OFFICIAL STAR CLASS MEASUREMENT CERTIFICATE

STAR NO. 2920

NORTH STAR II

Star No. 2920
NORTH STAR II

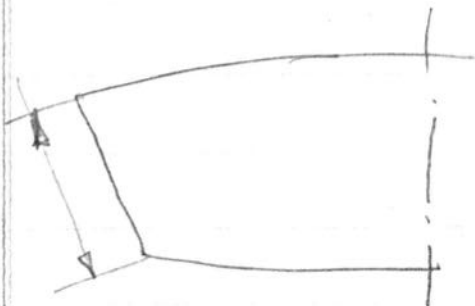
Remaining Controversial Dimension is
Side Height, at Station #10.

Re, Stueck ltr. 12/18/49, Side Height is $9\frac{1}{16}$ " scant

Still Scant

OK, disregard $\frac{3}{16}$ "

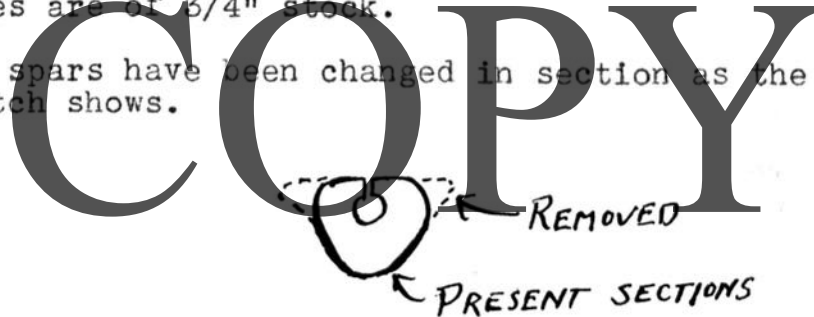
The side measurements at station 9 and 10 are 13" and 9 5/8" respectively. The knees of all the frames in the boat have had spruce knees added over the plywood knees. The spruce knees are of 3/4" stock.

The spars have been changed in section as the following sketch shows.
